# **APPLICATION FOR CERTIFICATE OF APPROPRIATENESS**

1616 Clinch Ave. 37916

# **Staff Report**

File Number: 9-D-24-HZ

1 ELEVATION - FRONT 1616 CLINCH

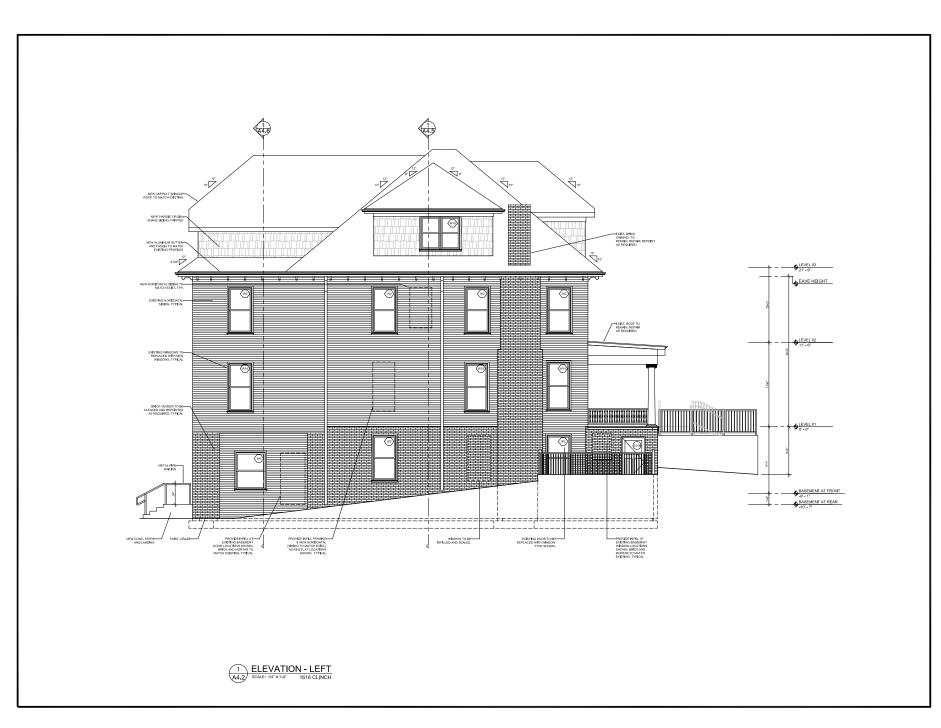
- 4. The proposed ramp is large in size, and will result in 13'-8" of additional projecting depth on the left side. Due to the height of the existing foundation, the ramp is also substantial in height, and will be approximately 5' tall at points. The ramp will obscure the original porch foundation.

- 5. The ramp is proposed to be constructed of concrete; in the opinion of staff, cladding the ramp in brick to match the existing foundation would reduce the ramp's visual impact. The ramp's railing should match or be compatible with the materials and design of the existing porch railing.

Staff recommends approval of Certificate 9-D-24-HZ, subject to the following condition: 1) access ramp to be clad in brick veneer to match house's foundation and feature a railing compatible in materials and design with the porch.
